CLOVERLEAF FILING 2
 POND PLANS AND DETAILS
 SHEET 19 OF 28
 JOB NO. 25158.01

AS-BUILTS
05/24/2023
SF-21-023

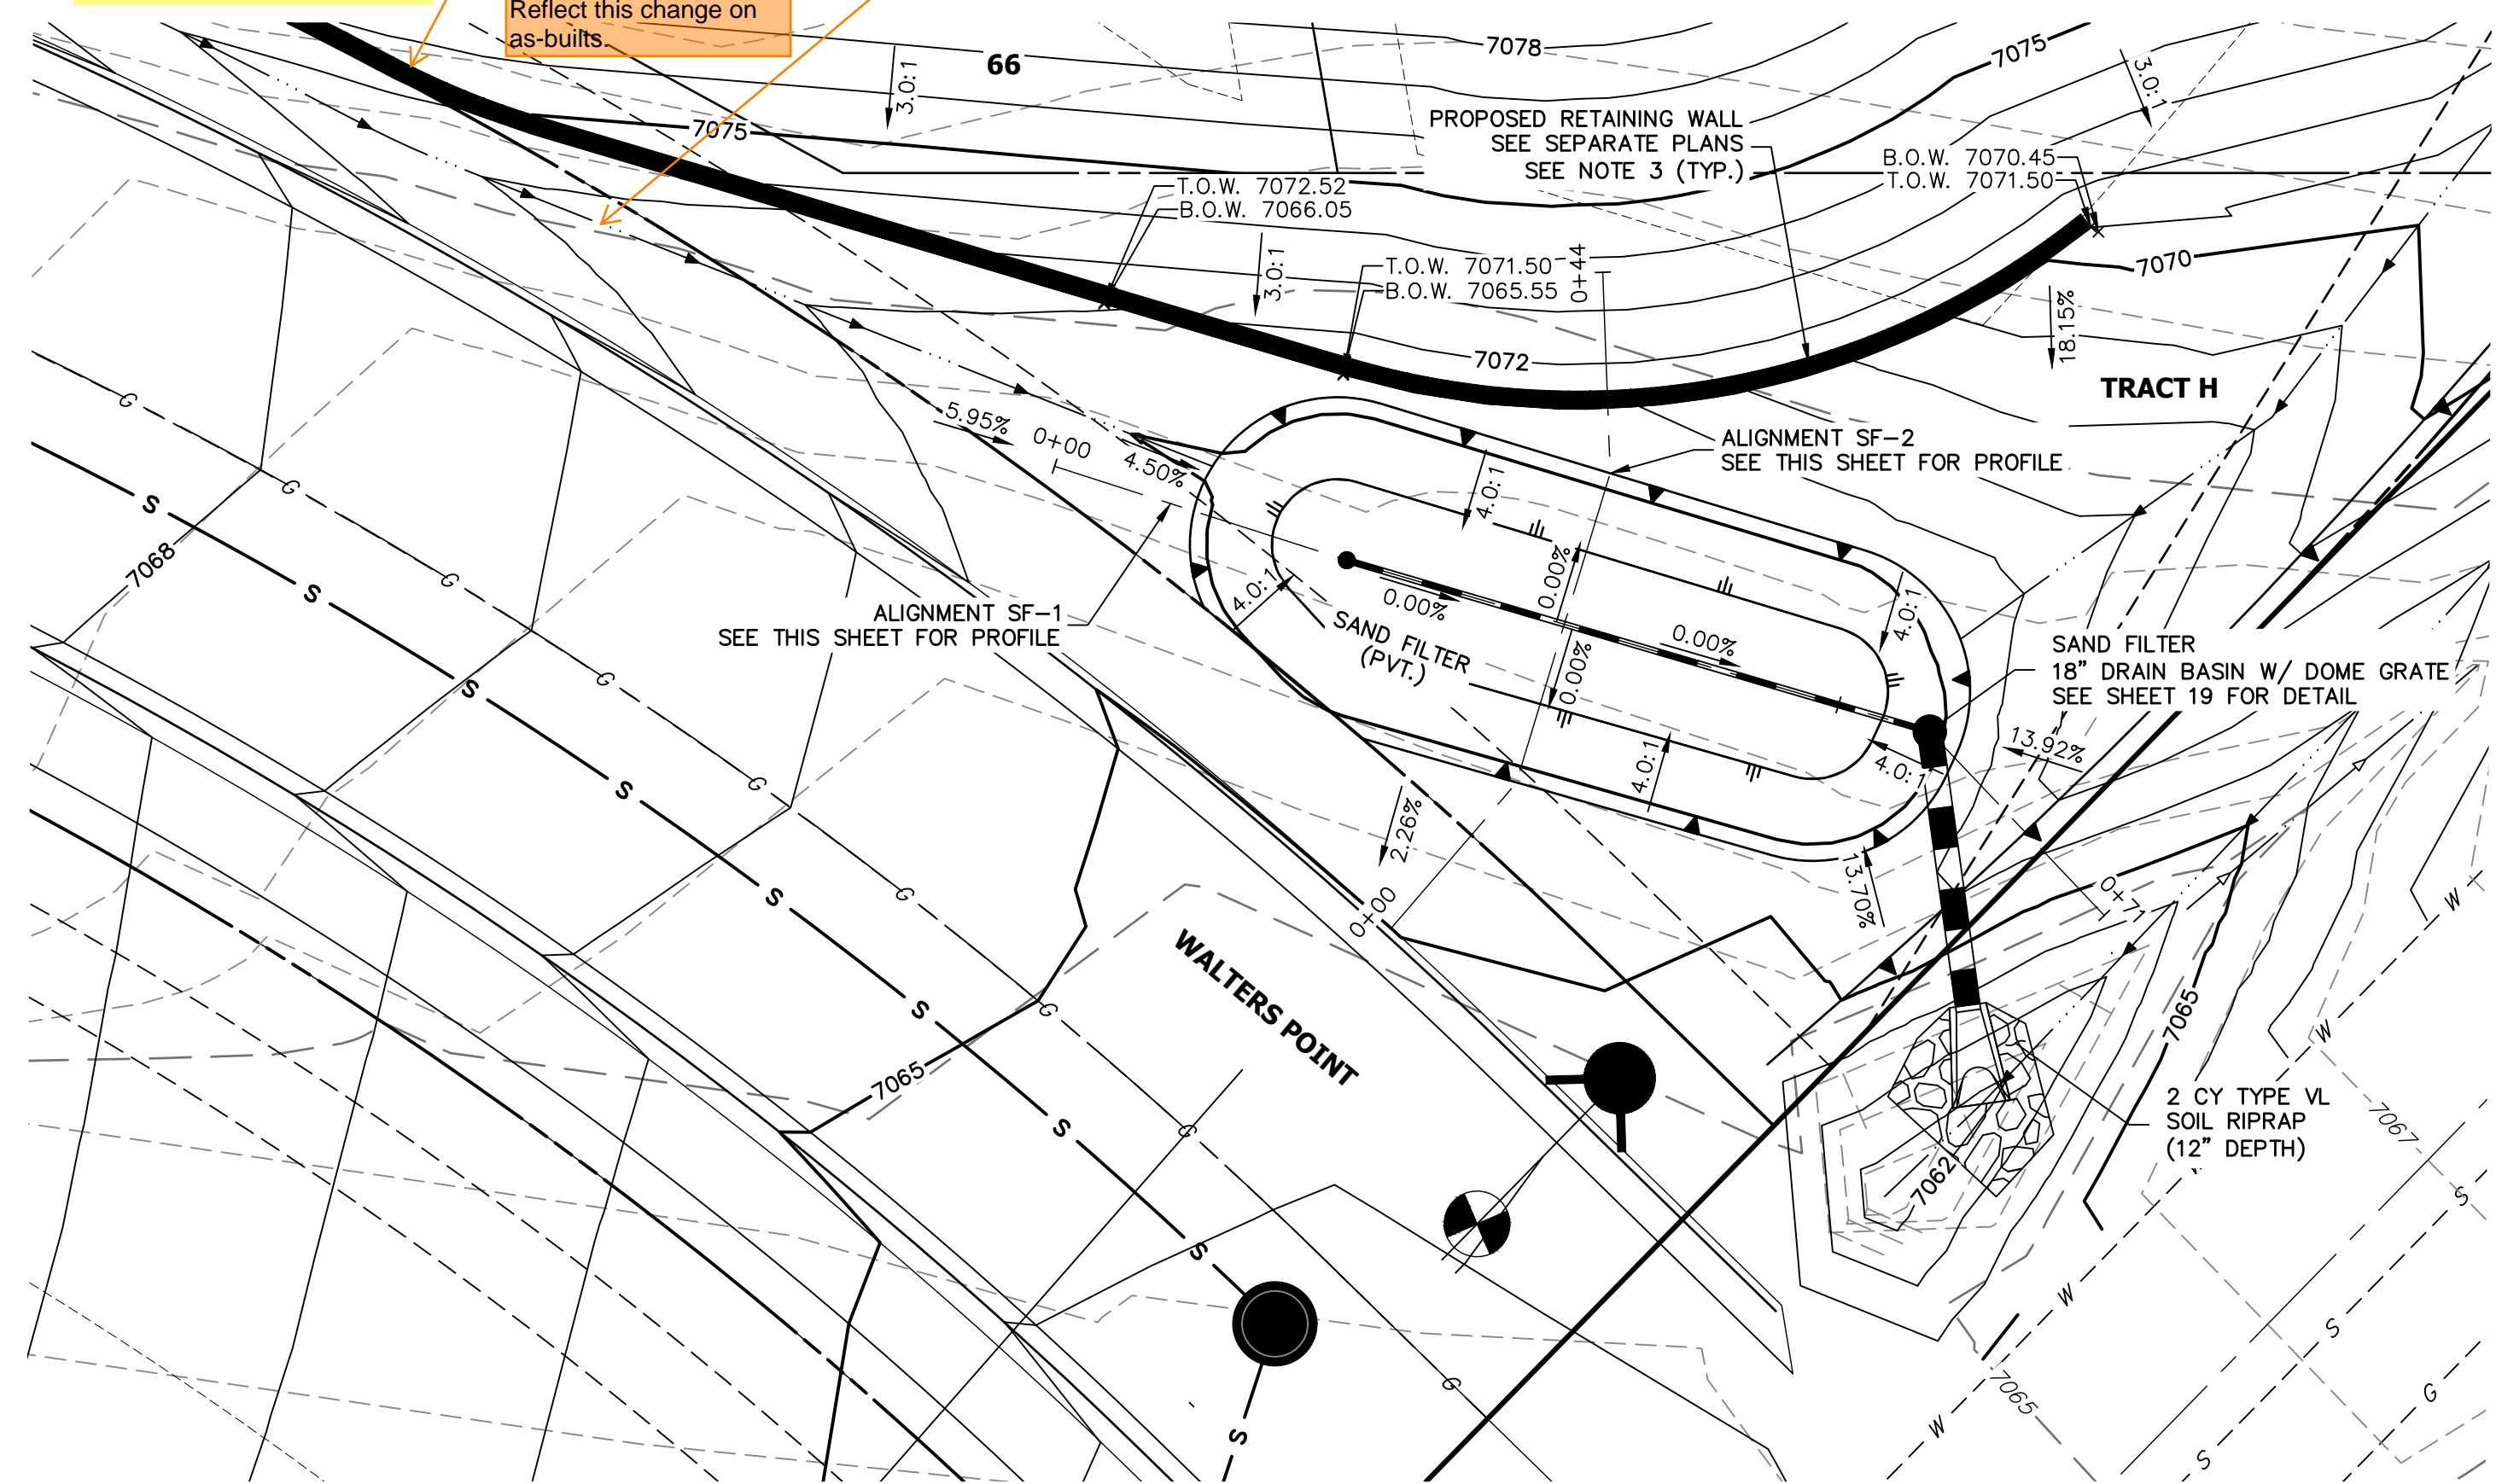
This is the new Stage=0ft point for the MHFD-Detention calcs. So the other two inputs for 'Stage of Orifice Centroid' will all need to be adjusted accordingly in that spreadsheet.

In this specific situation, as the AB pipe out is above stage zero, and therefore, the first hole will have zero outflow until WSEL = Invert out = 49.67 as modeled in the AB MHFD Detention workbook.

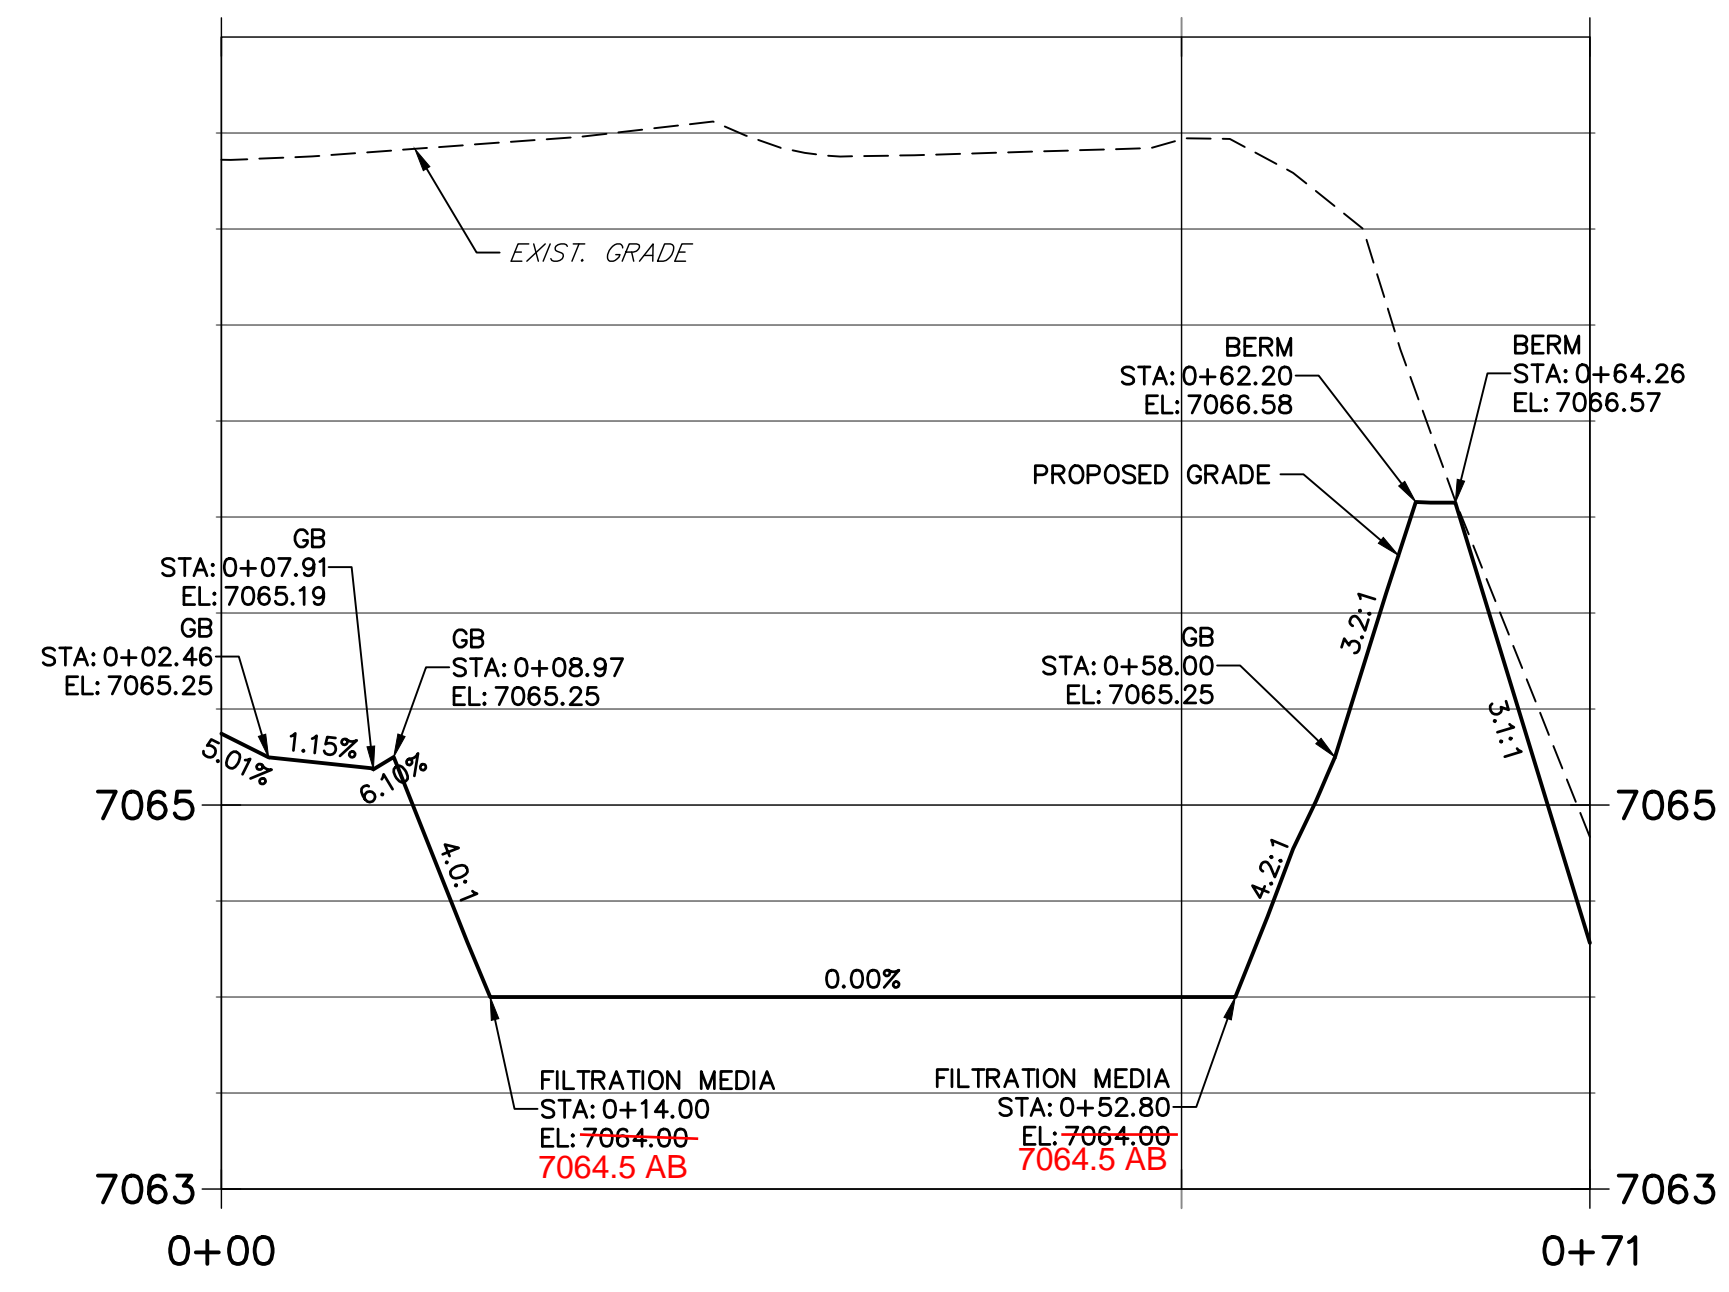
Unresolved previous comment: Retaining wall actually installed closer to street than shown on plan. Reflect this change on as-builts.

Unresolved previous comment: Ditch not installed per plan

This wall was built per plan. This documents is not intended to be an "as-built" for the retaining wall.

This swale has been installed per plan and was confirmed by a field visit, December 2023.
